WELL NO. **GREEN RIVER FEDERAL #1-20** API NO. **43-019-31326**

APPLICATION FOR PERMIT TO DRILL, DEEPEN, OR PLUG BACK

Other Revise surface location.

Proposed surface location has been revised. New location is 778' FEL, 2209' FSL, as witnessed and approved by BLM.

CHEVRON U.S.A.
 WELL: #1-20
 GREEN RIVER
 PRELIMINARY WELL PLAN

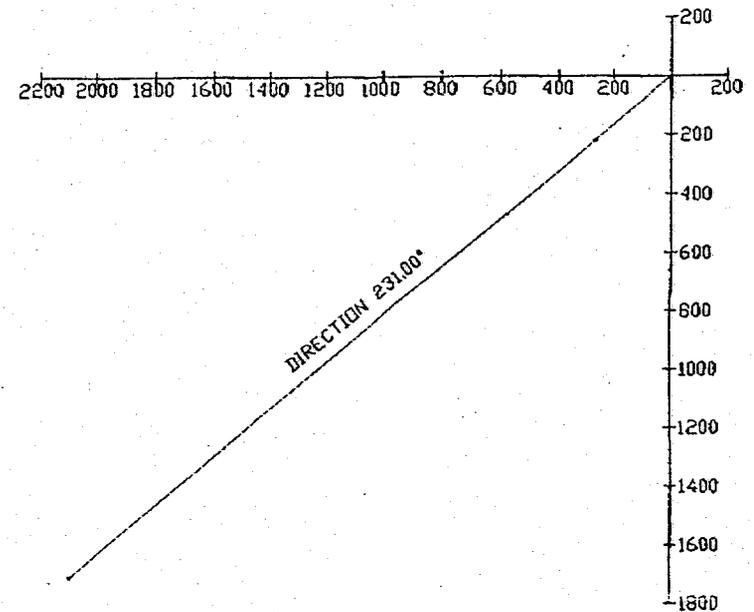
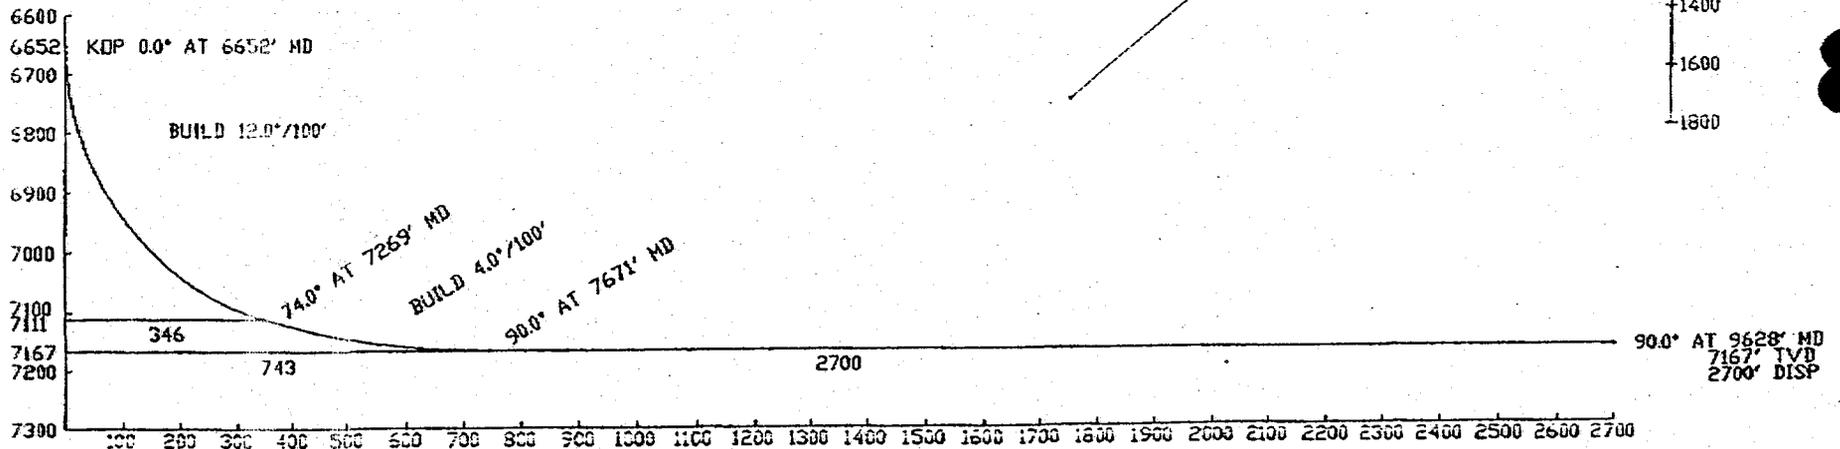
The following changes are results of the revised surface location:

1. Change the horizontal well azimuth and displacement from the revised surface location to 2700 feet at S51°W.
2. The True Vertical depth of the well to remain 7167 feet unless revised from open hole evaluation. The Measured depth to be changed to 9628'.
3. The new bottomhole location to be: 510' FSL, 2404' FWL, Sec. 20, T25S, R18E.
4. Change the 9-5/8" casing depth to ±4800' to put the casing shoe into the Desert Creek and therefore give us an adequate shoe test before drilling ahead.

Revised drilling and geologic programs attached
